FOCUSED REVIEW OF:

"Conceptual Considerations of the Yucca Mountain
Groundwater System with Special Emphasis on the
Adequacy of this System to Accommodate a
High-Level Nuclear Waste Repository",
by Jerry S. Szymanski, U. S. Dept. of Energy,
Las Vegas, Nevada, July 26, 1989

Letter Report No. 20-3702-001-102

Rachid Ababou
Center for Nuclear Waste Regulatory Analyses
San Antonio, Texas

MOHR DIAGRAMS
 (Figure 7 From Shaw, 1980)

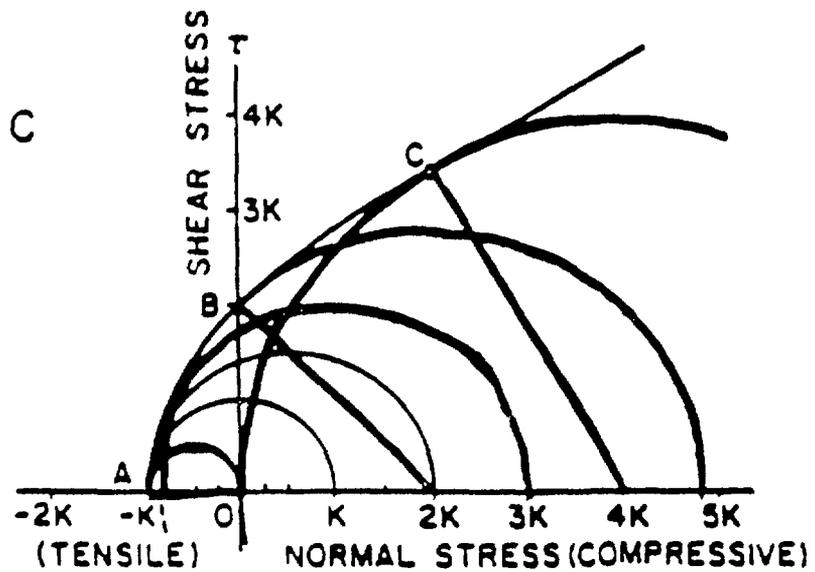
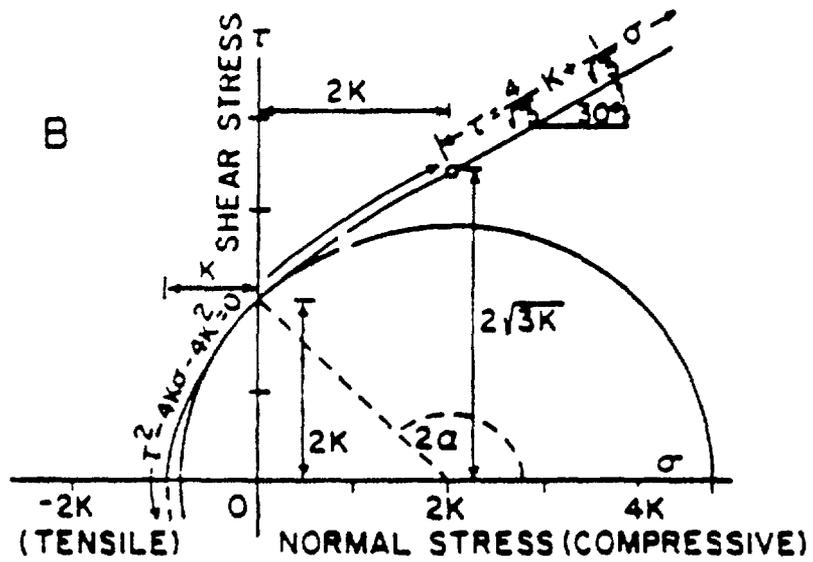
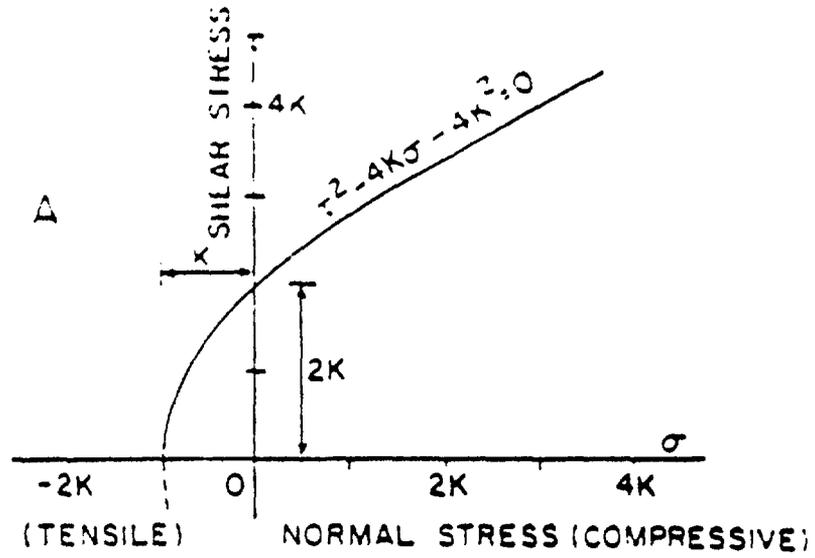
From now on, define α as the angle of the failure plane. The angle α is given graphically, as indicated in the centerpiece of the attached Figure 7 from Shaw (1980).

- (2): Both the Coulomb and the Griffith theories of failure assume failure occurs at a given point on the Mohr circle. As σ_1 and σ_3 vary, the curve described by these points forms the failure envelope, $\tau=f(\sigma)$. In the Griffith model, that envelope is a parabola (see top part of Shaw's Figure 7):

where K is the "tensile strength", by definition equal to the value of the normal stress at failure under conditions of zero shear stress. (Shaw's Figure 7: A, B, and C). In order to understand the consequences of both the Griffith's failure model and the composite Griffith-Coulomb model, it is necessary to clearly label the (τ, σ) axes in terms of the tensile strength K (Shaw's Figure 7: A, B, and C). In the attached [Plate 3.3.3.2-1] from the JSS report, the tensile strength is denoted T ; it can be seen that the positive σ -axis is not labeled in terms of T , and furthermore, the τ -axis is improperly labeled ($\tau=2T$ should be the intercept at point B). In addition, although this is difficult to tell from the poorly labeled plate, it seems that the negative σ -axis is also improperly labeled ($\sigma=-T$ should be the normal stress value at the point labeled A, not at the point labeled σ_3).

- (3): The consequences of the Griffith-Coulomb model regarding the orientation of failure planes is succinctly described in the attached caption of Figure 7 from Shaw (1980). One may also use equation (12) for obtaining $\tan \alpha$, where α is the angle of the failure plane with the x_3 -principal axis. Note in particular that purely extensional failures correspond to Mohr circles tangent to the failure envelope at point A. This mode of failure is correctly described by the following sentence in the JSS report: "Only if the stress circle touches the envelope at point A will pure tensile failure result". In fact, it can also be said that this mode of failure occurs on planes with $\alpha=90$ degrees, and that the largest compressive principal stress for which this can occur is $\sigma_1=3K$, while the smallest principal stress reaches tensile strength: $\sigma_3=-K$.

- (4): For Mohr circles tangent to the failure envelope between points A and B, failure occurs at angles α decreasing from 90 degrees at A to 67.5 degrees at B (see Shaw's Figure 7). This corresponds to a mixed

shear-extensional mode of failure, since the stresses in the failure plane satisfy $\tau \neq 0$ and $\sigma < 0$ (indicating extension). No quantitative insights are provided in the JSS report regarding the possible orientation of failure planes.

- (5): For Mohr circles tangent to points between B and C of Shaw's Figure 7, there is a transition between dominantly tensile and dominantly compressive shear modes of failure (see caption of Fig. 7 from Shaw, 1980). To the right of point C of Shaw's Figure 7 starts the regime of compressive shear failure, and the angle α becomes less than 60 degrees. In comparison, note that JSS places a point C at an arbitrary location to the right of B [Plate 3.3.3.2-1, attached], and states without correctly explaining the compressive shear mode of failure: "If the stress circle touches the failure envelope between B and C, a shear failure result" [p. 3-31]. This is a poorly worded and partially incorrect description of the shear modes of failure to the right of point B.

Figure 2.2 Typical Shear Stress vs. Shear Deformation Curves.

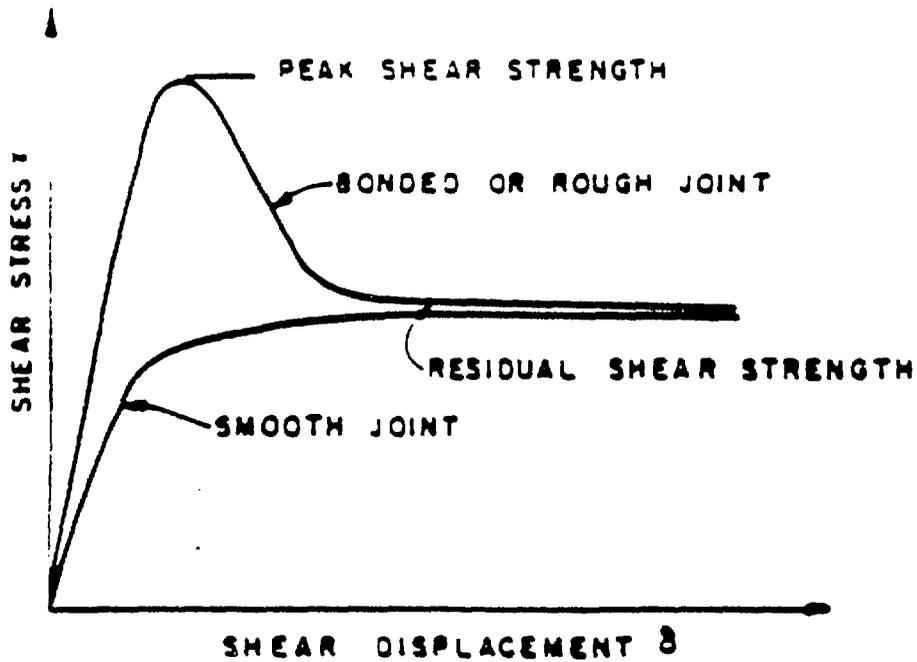
- The remaining remarks below concern other rock mechanics issues, perhaps more intricate than the basic material analyzed above. On [Plate 3.3.3.2-3] and [p.3-32] several new notions concerned with rock joint behavior are introduced without much elaboration. The top part of [Plate 3.3.3.2-3] indicates that rock joint behavior is being modeled by a shear stress versus strain relation of the "smooth joint" type, as can be seen by comparing to Figure 2.2 from Scott (1982), attached to this review report. However, a bonded joint would show a peak in the shear stress/deformation curve, as also indicated in Scott's Figure 2.2; the peak shear strength may be given by the Coulomb failure model:

$$\tau_{\max} = \tau_0 + \sigma_n \tan \phi \quad (15)$$

where τ_0 (also denoted C) is the cohesive stress. However, for a non-bonded joint, it is more likely that $\tau_{\max} = \sigma_n \tan \phi$, without cohesion. The term "peak displacement" used by JSS is misleading since displacement continues to increase after peak shear stress is reached. Finally, even the above-corrected model based on Coulomb failure may be too ideal. The alternative models of Patton, Jaeger, Barton, and Ladanyi and Archambault (described in Scott, 1982) attempt to take into account the processes of dilatation (riding up on asperities) and grinding (shearing through asperities) that may occur at low and high normal stresses.
